ADDENDUM

RFB NO. 322027 - ADDENDUM NO. 4

WINDOWS REPLACEMENT

**PROJECT: WINDOW REPLACEMENT
CITY-COUNTY BUILDING**

PARTIAL FLOOR PLAN

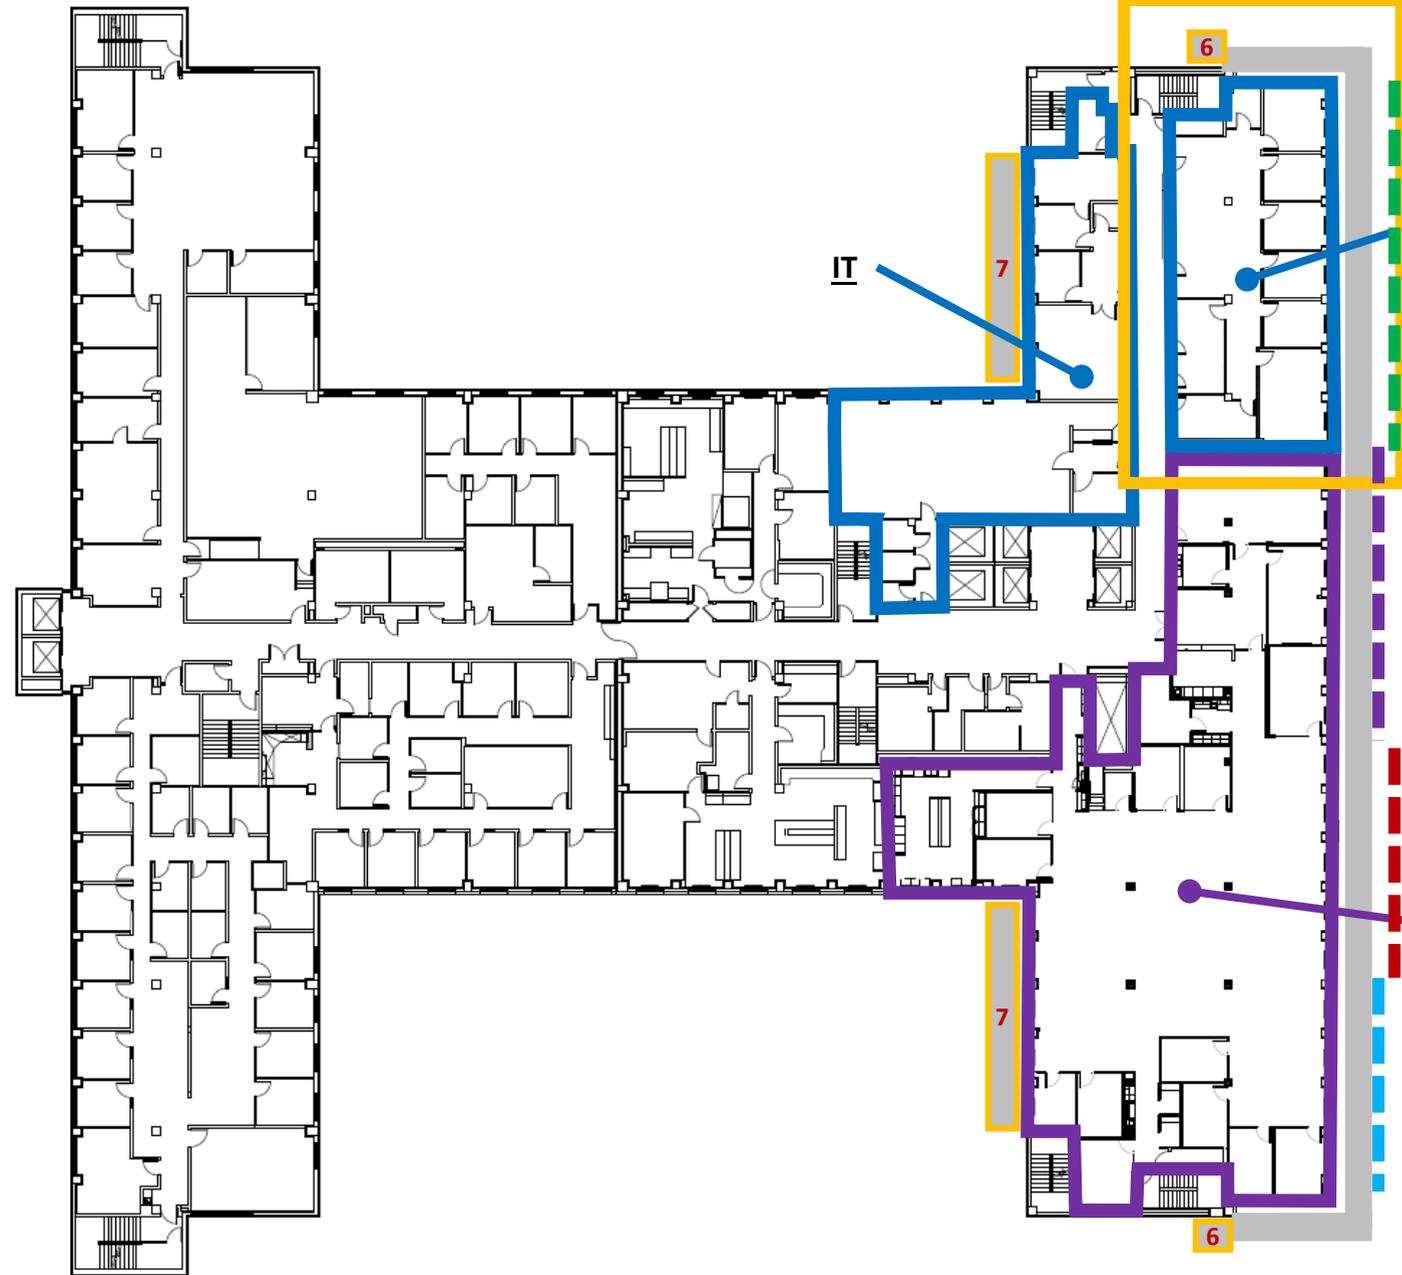
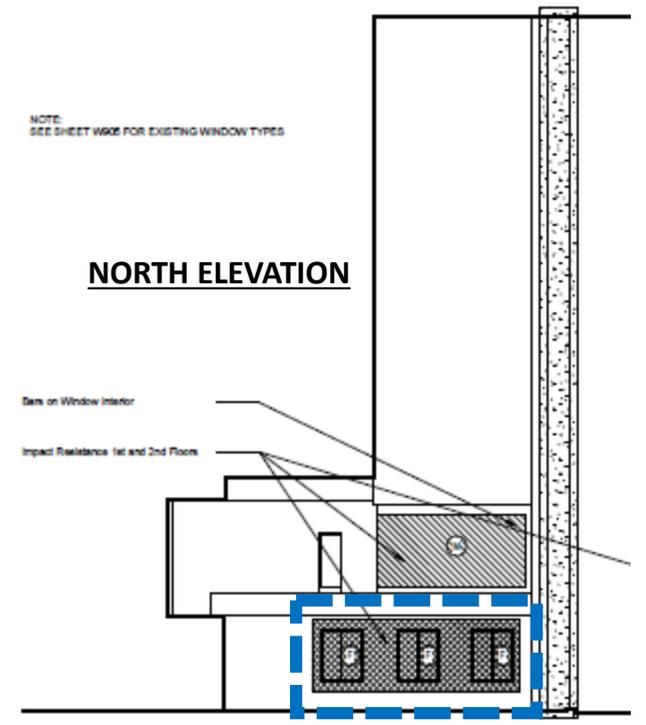
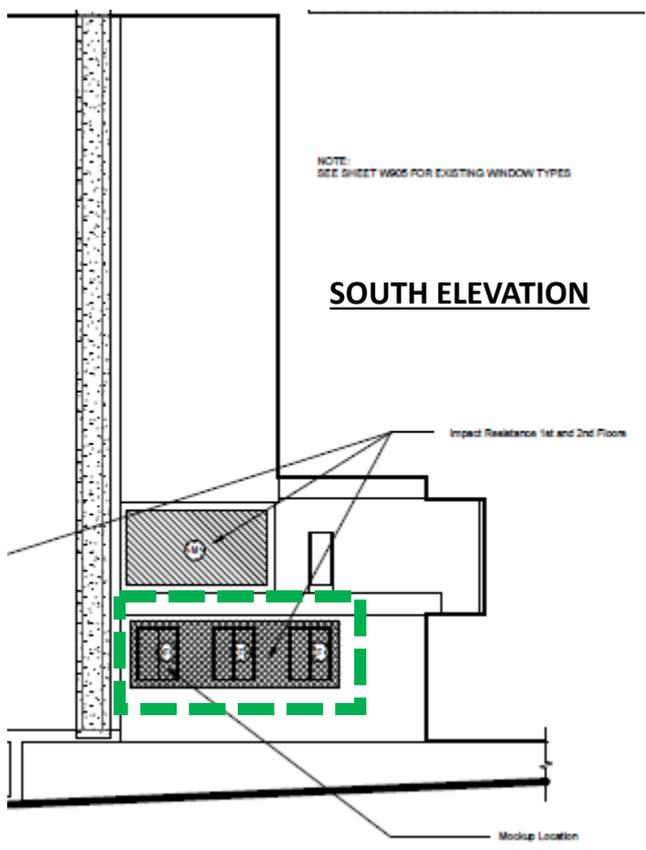
“H. Refer to Figures 1 - 7 for Base Bid work sequence & phasing. Alternate Bids work sequence & phasing shall be worked out with Contractor before any work commences.”

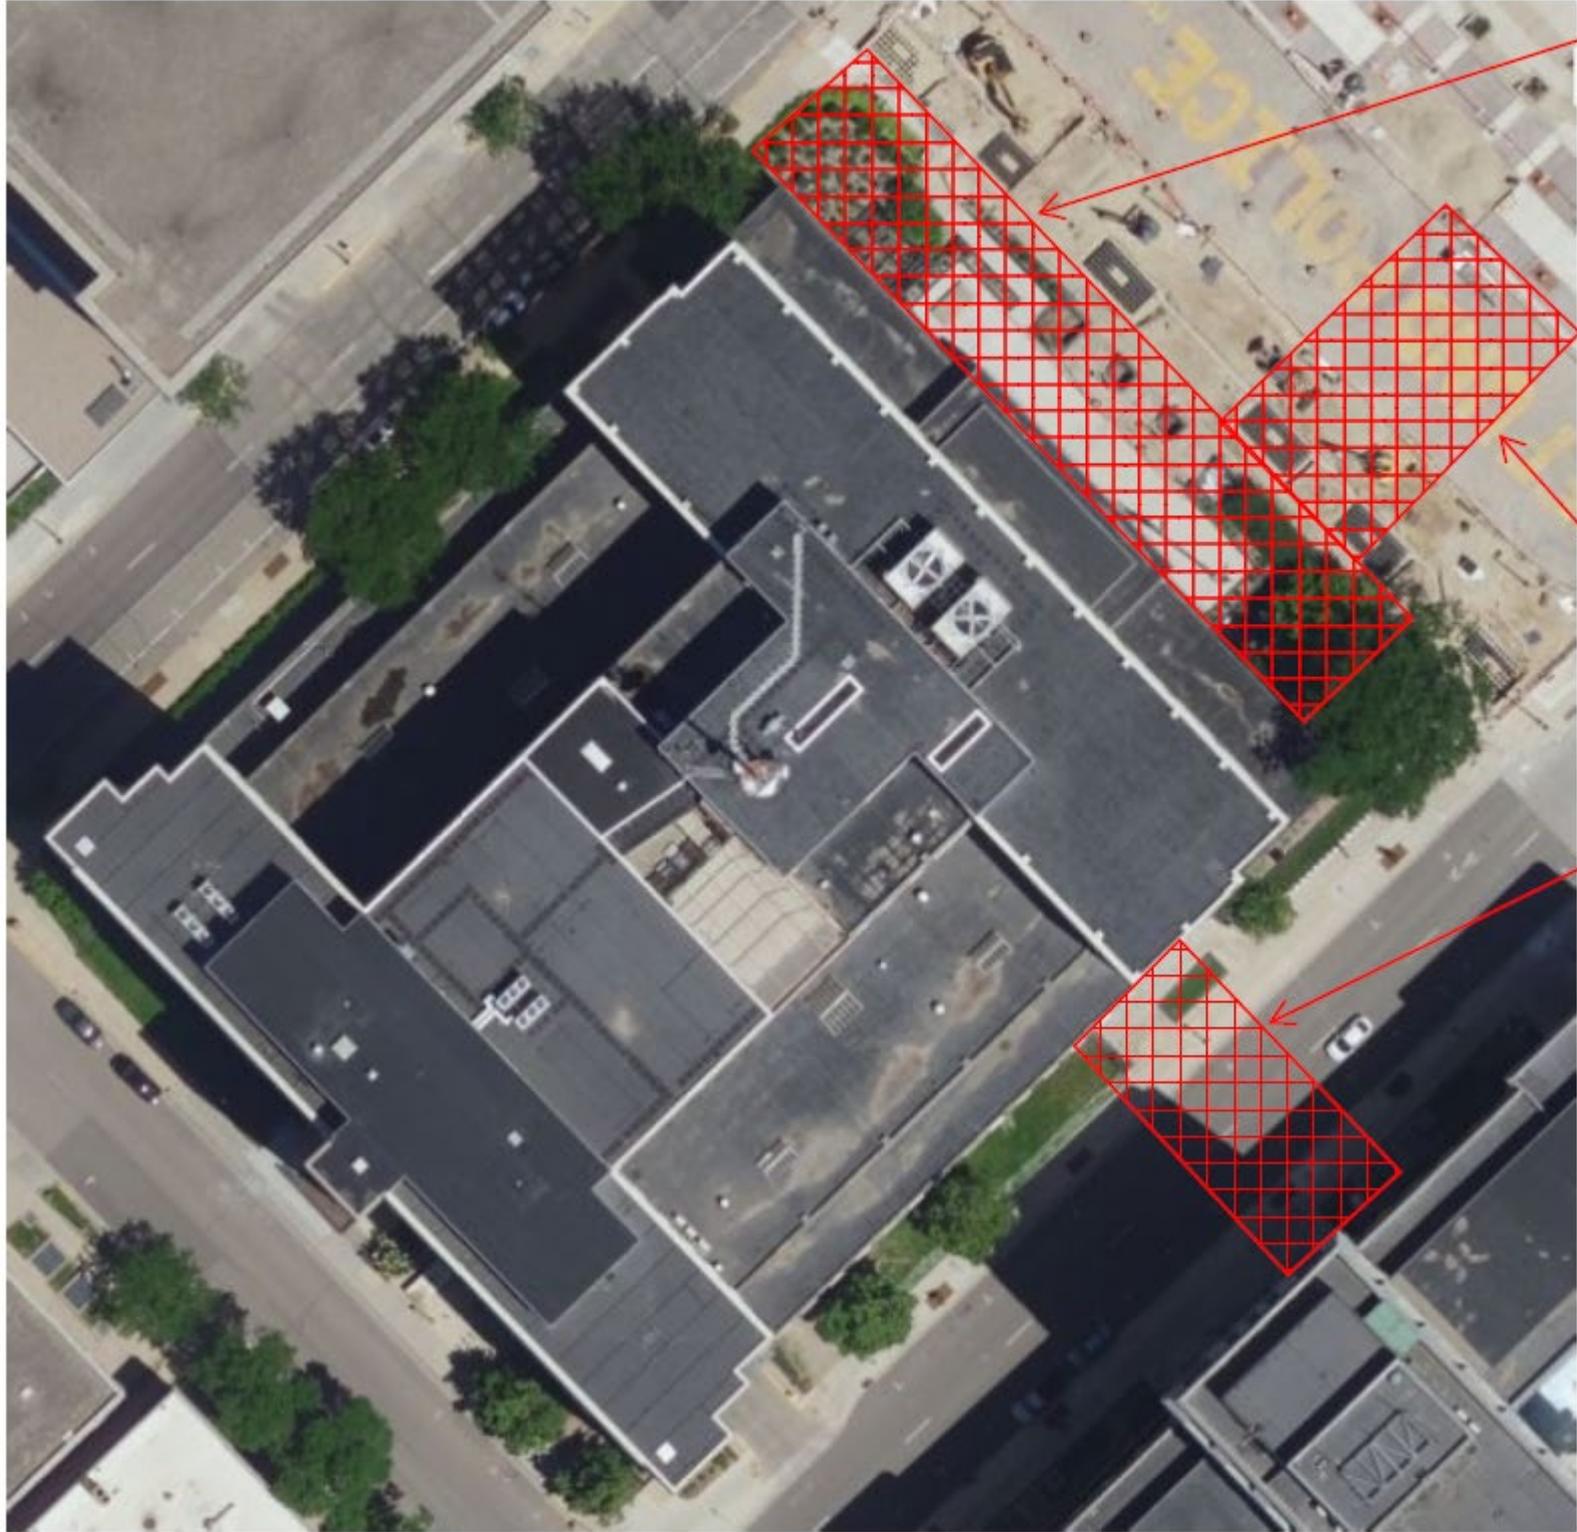
“D. All work is to be conducted by use of swing stages. Use of ladders or basket lifts to perform work is not permitted. Contractor shall be responsible for having a competent certified person in charge of erection and safety of swing stages at all times. Refer to Figure 8.”

The cross-hatched areas cannot bear the weight of cranes, lifts, lulls or boom trucks. Stay off these areas with any heavy equipment.
